HARTFORD ZONING BOARD OF ADJUSTMENT
November 8, 2023
Meeting Notice and Agenda

Application #12-23

**Application #12-23 by 747 Hartford Avenue LP
for an amendment to an approved multi-unit dwelling
to allow temporary construction access on Goudreau Street
lot 43-0074-001, 747 Hartford Avenue, Wilder
in an approved Planned Development**

**Application #13-23 by Black Rock Investments LLC
for Conditional Use Approval
for 192 dwelling units in four multi-unit buildings
proposed lot 45-0162-000, Sykes Mountain Avenue and Hickory Ridge
White River Junction, in a proposed Planned Development**

BLOW UP OF SHEET C1.4

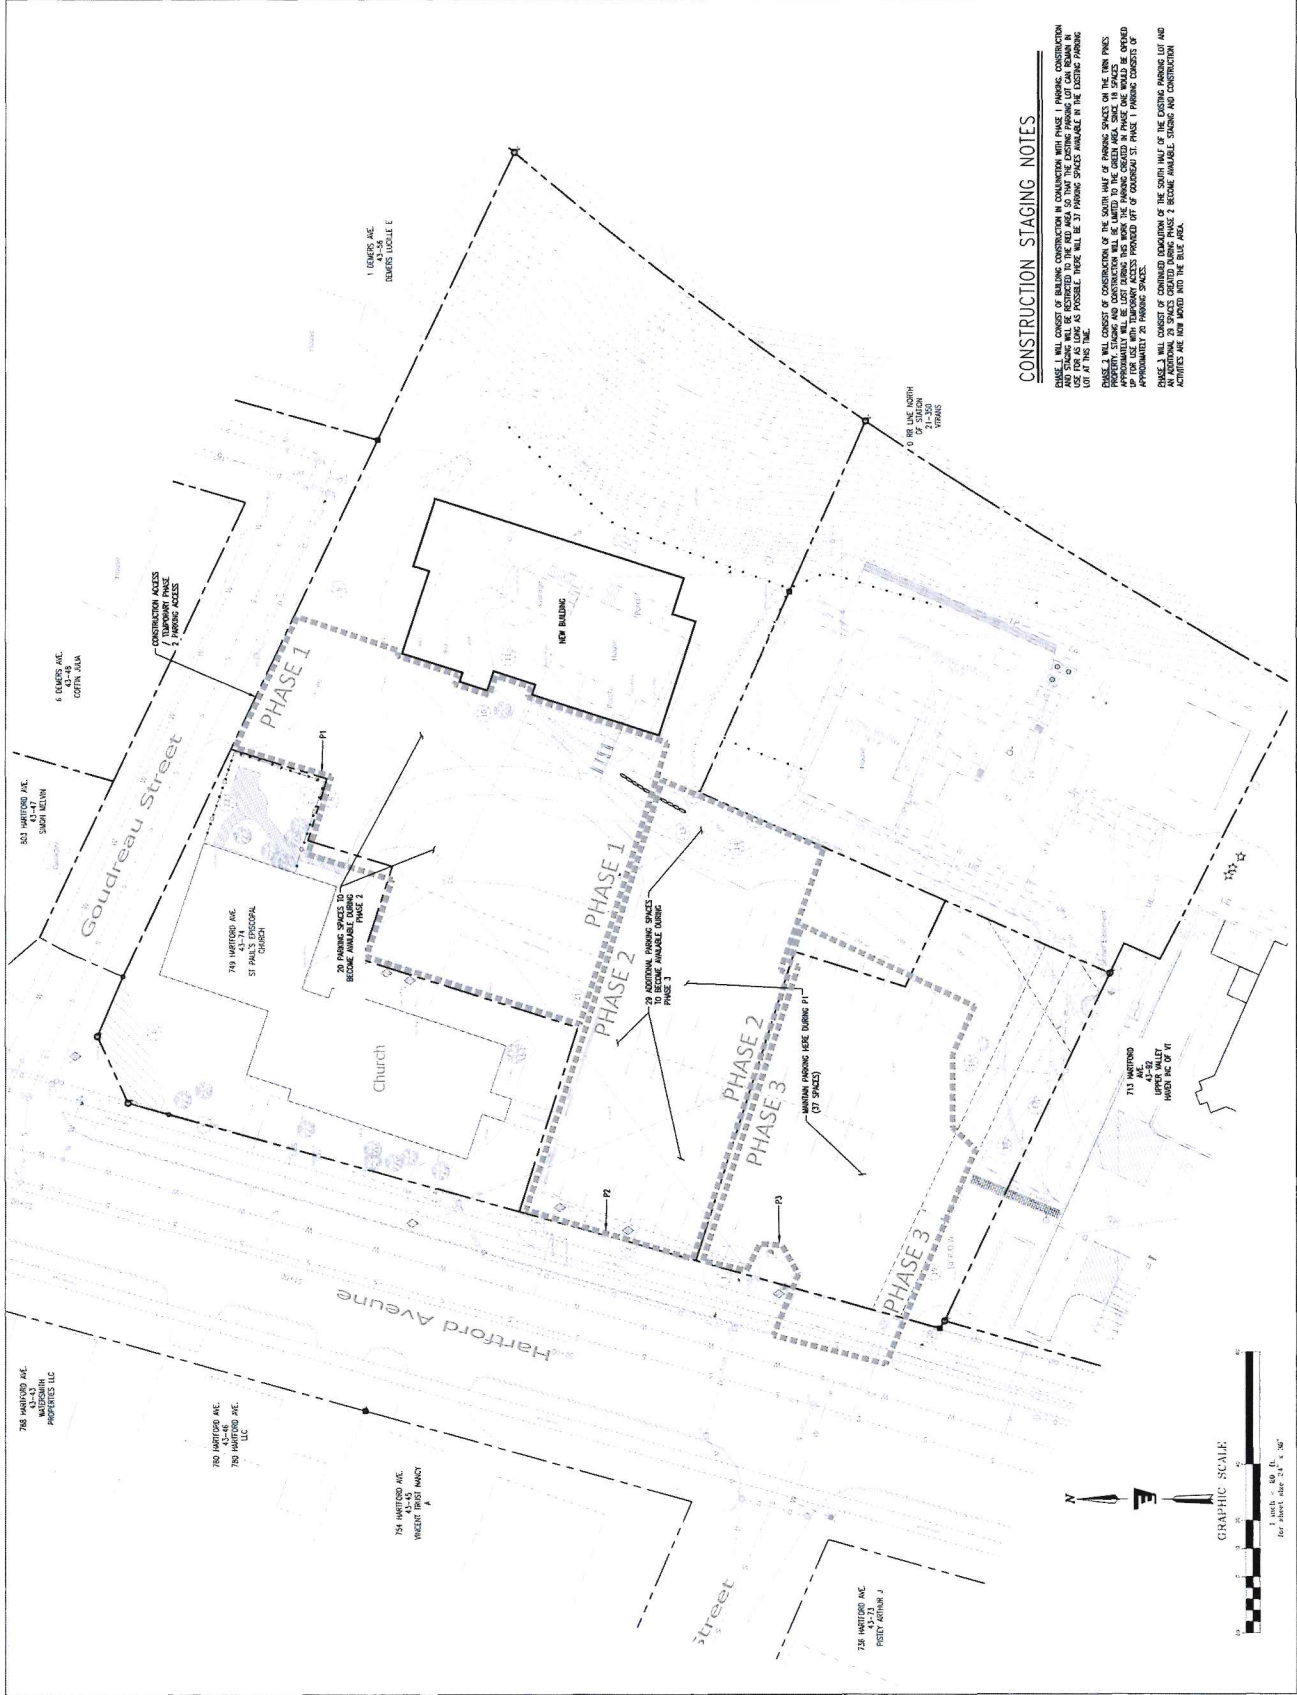
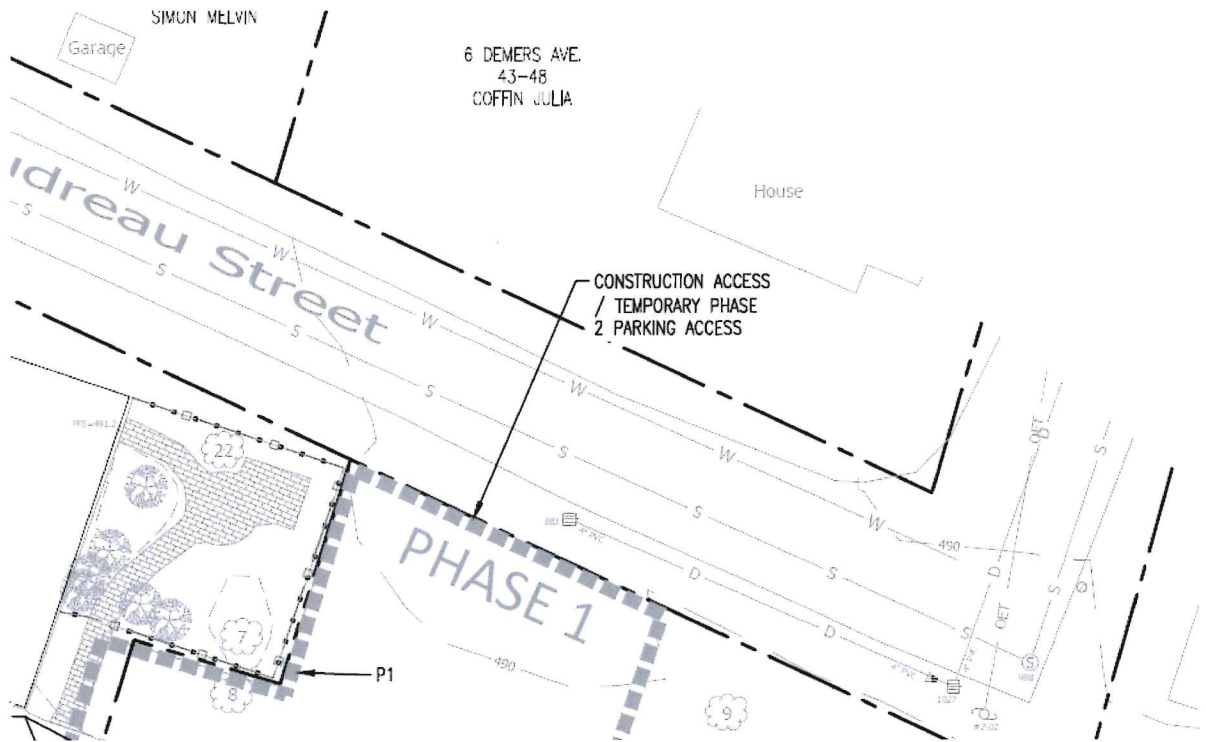
Site Plan sheet C1.4, Construction Staging Plan (See Exhibit 1), shows the construction phasing for the project. Where construction Phase 1 borders Goudreau Street, there is a plainly marked caption "Construction Access/Temporary Phase 2 Parking Access." While the Erosion Prevention and Sediment Control plan (Sheet C1.2) shows a stabilized construction entrance off of Hartford Ave, that was for Phases 2 and 3.

A. Morse: It's actually on that plan too under the construction staging notes, so. The idea was to have access off, temporary access off Goudreau for just during construction.

- The parking lot is at or near capacity during most business hours. If this parking lot were to be the only access, two thirds of the lot would need to be closed to provide turning radius for delivery trucks to enter the site. Straight trucks would then need to turn around after the delivery and exit via the parking lot due to the constraints of the available staging area in the designated phase 1 area.

- We had planned on tractor trailer deliveries accessing through the parking lot when coordinated with the Haven so they could get to the site, and then exiting via a left turn on to Goudreau. If this access is closed, the trucks would need to be backed out of the site through the parking lot and out onto Hartford Avenue. There is always a significant amount of pedestrian traffic in the parking lot, not to mention vehicle traffic on Hartford Avenue. This approach eliminates potential hazards to both pedestrian and vehicular traffic.

- **Notes E6 and E7 on the Erosion Prevention and Sediment Control Plan, Sheet C1.2, are updated to indicate that Hartford Avenue and Goudreau Street will be used as construction accesses for all phases of construction.**
- **The applicant verifies that changes to the plans approved by the Zoning Board of Adjustment are limited to those required by the Board.**
